# Wizards Workshop

June 13, 1980  
Issue 10-12

## 1480 SERIES/SPACER REQUIRED FOR PUSHBUTTON SWITCHES

1480R

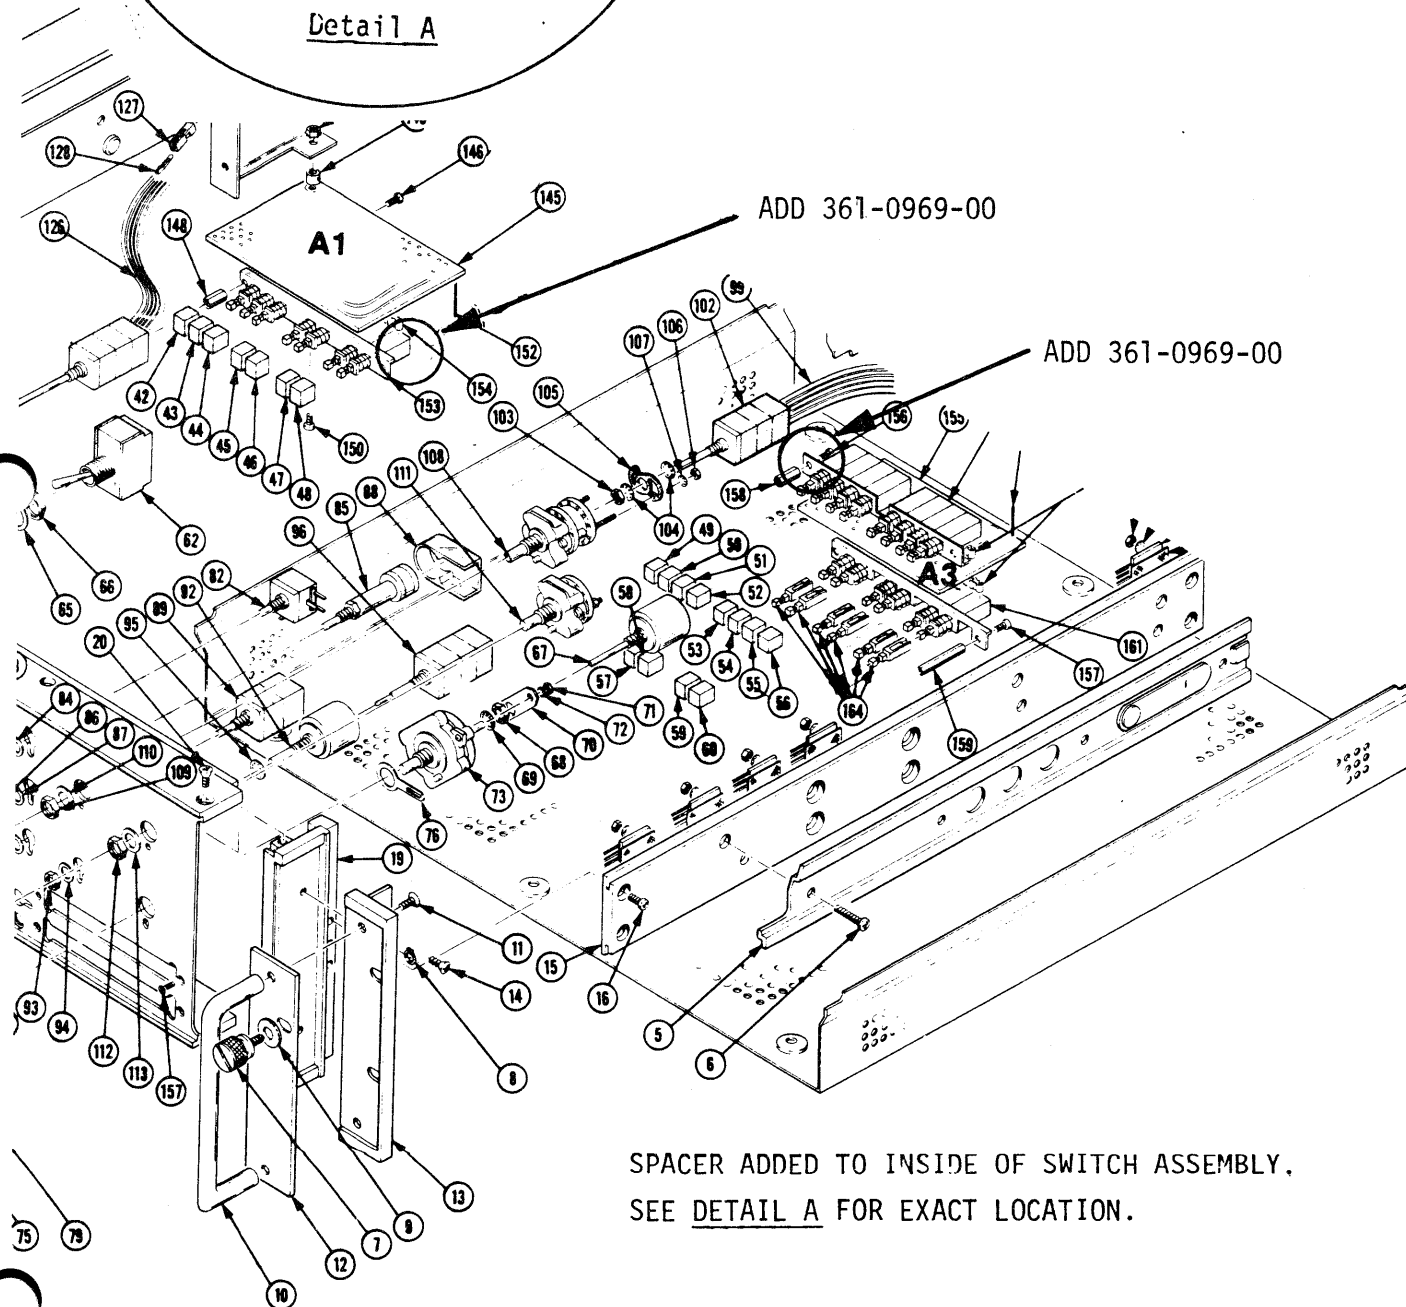
ADD 210-0261-00  
BEND TAB AT 90°

SPACER ADDED TO INSIDE OF SWITCH ASSEMBLY,  
SEE DETAIL A FOR EXACT LOCATION.

CHANGE (6) MOUNTING SCREWS FROM 211-0267-00  
TO 211-0232-00.

1480C

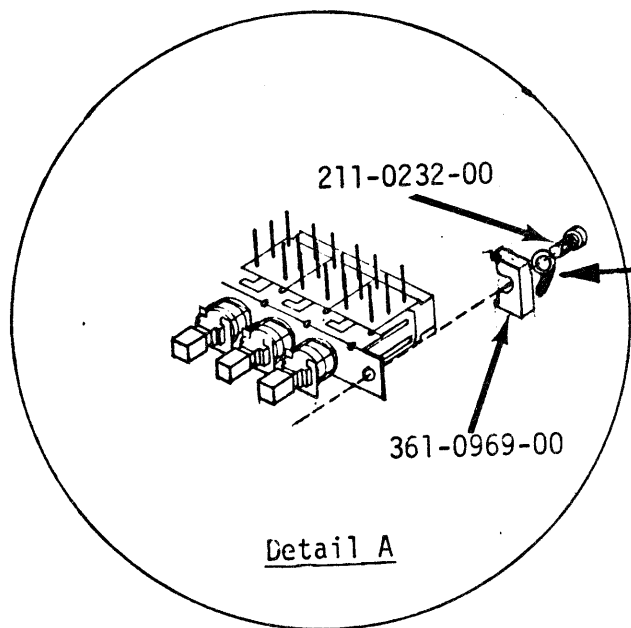
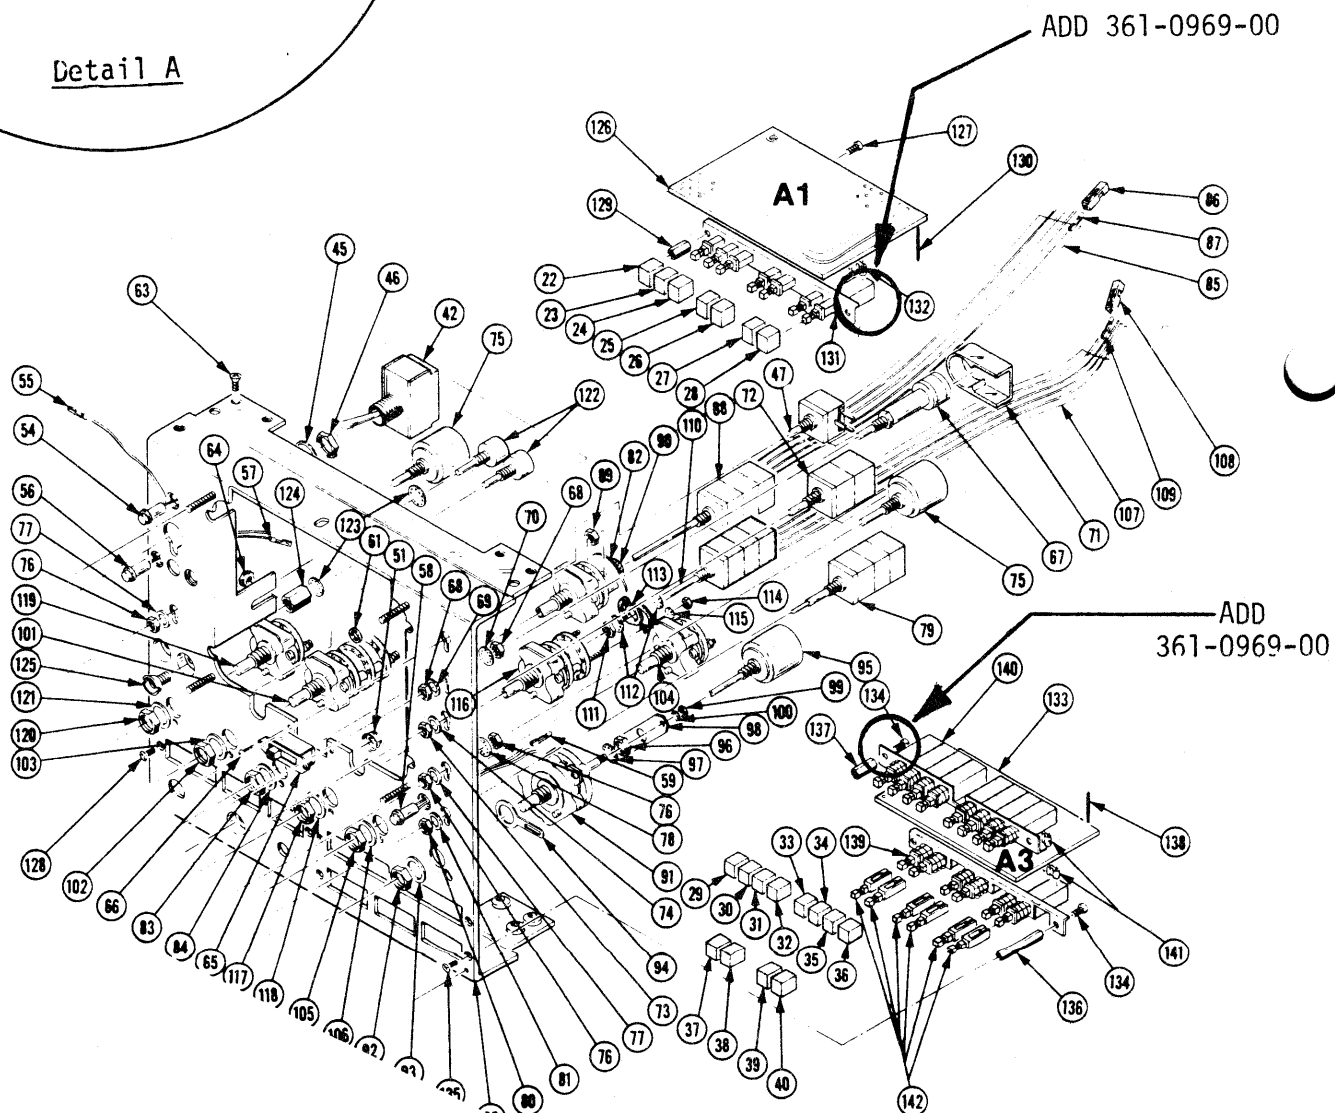
SPACER ADDED TO INSIDE OF SWITCH ASSEMBLY. SEE DETAIL A FOR EXACT LOCATION.  
CHANGE (6) MOUNTING SCREWS FROM 211-0268-00 TO 211-0232-00.
